DEPARTURE LOG

Well Name: WILD WASEL #1	Lease: OCS-Y 1597 #1	Operator: ARCO
--------------------------	----------------------	----------------

Well Name: WILD WEASEL^{#1}	Lease: OCS-Y 1597^{#1}	Block 760
Area: CAMDEN BAY BEAUFORT SEA	Operator: ARCO	Drill Unit: KULLUK

Subject: Sundry Notice #4, Form MMS-331
OCS-Y-1597 #1, Block 760
Beaufort Sea, Alaska

ANCHOR PATTERN

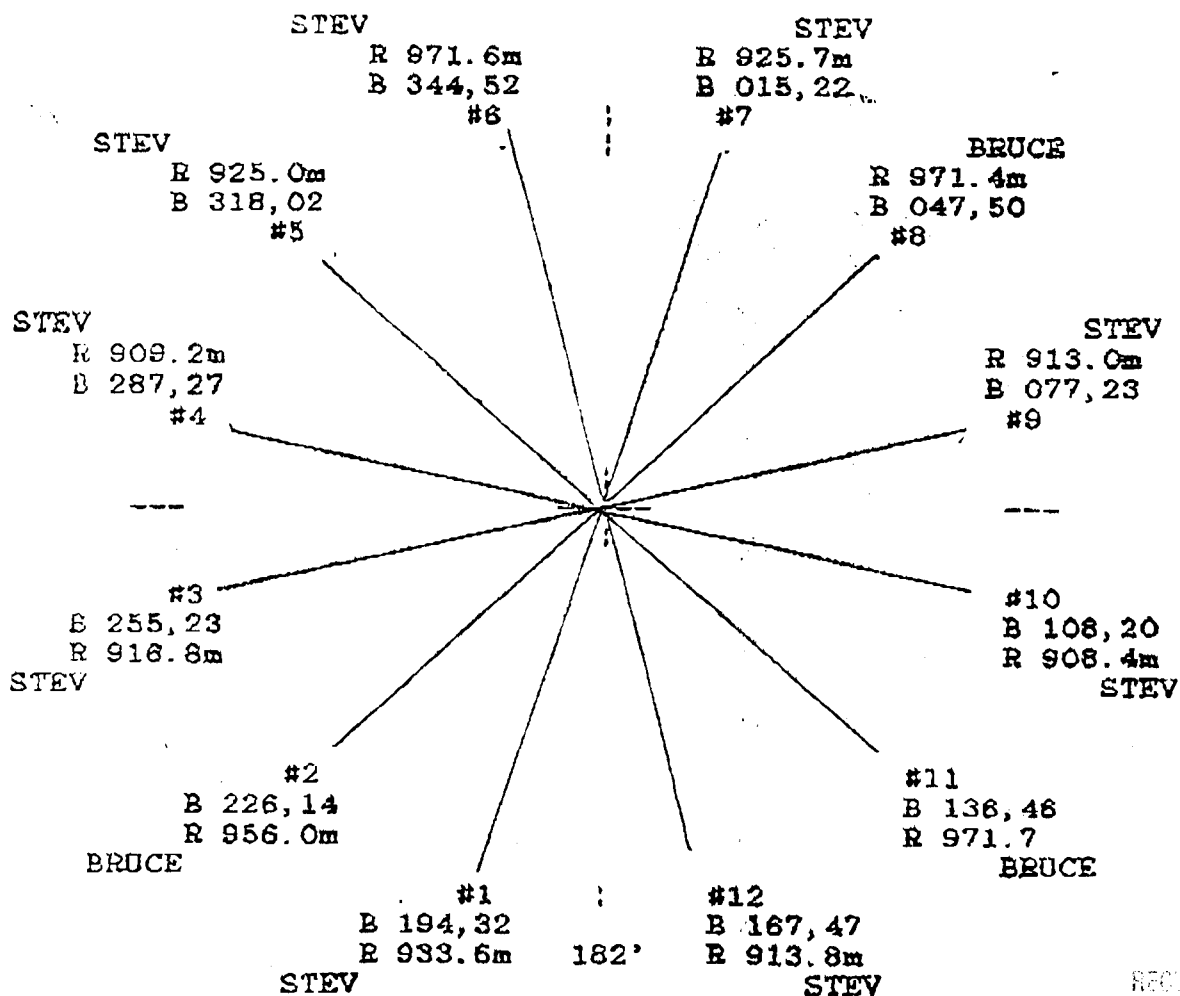
Date	Departure	Verbal or Written?	Written Follow-up
① 11/6/93	Reduce # of anchors deployed (from 12 to 8)	VERBAL	YES; 11/8/93 sundry Notice
② 11/6/93	offload oil spill response equipment from supplier to demobilization barge prior to P&A	VERBAL	YES; 11/8/93 sundry Notice
③	offload barite (dry) from Kulluk to barge	VERBAL	YES; 11/8/93 sundry notice

<u>Date</u>	<u>Departure</u>	<u>Requested by</u>	<u>Verbal/Written</u>
① 11/6/93	REDUCE [#] OF ANCHORS DEPLOYED FROM 12 TO 8.	MIKE WINFREE (ARCO)	VERBAL
② 11/6/93	OFFLOAD OIL SPILL EQUIPMENT FROM SUPPLIER TO DEMOB. BARGE PRIOR TO P&A.	MIKE WINFREE (ARCO)	VERBAL
③ 11/6/93	OFFLOAD BARGE (DRY) FROM KULLUK.	MIKE WINFREE (ARCO)	VERBAL

ARCO REQUESTED DEPARTURES (NOTED ABOVE) ON 11/6 TO ENABLE
QUICKER DEMOBILIZATION OF THE RIG. WELL CURRENTLY BEING
LOGGED. PLUGGING OPERATIONS BEGAN 11/8/93. BARGE RELEASED
FROM KULLUK LOCATION @ 1630 HRS 11/8/93.
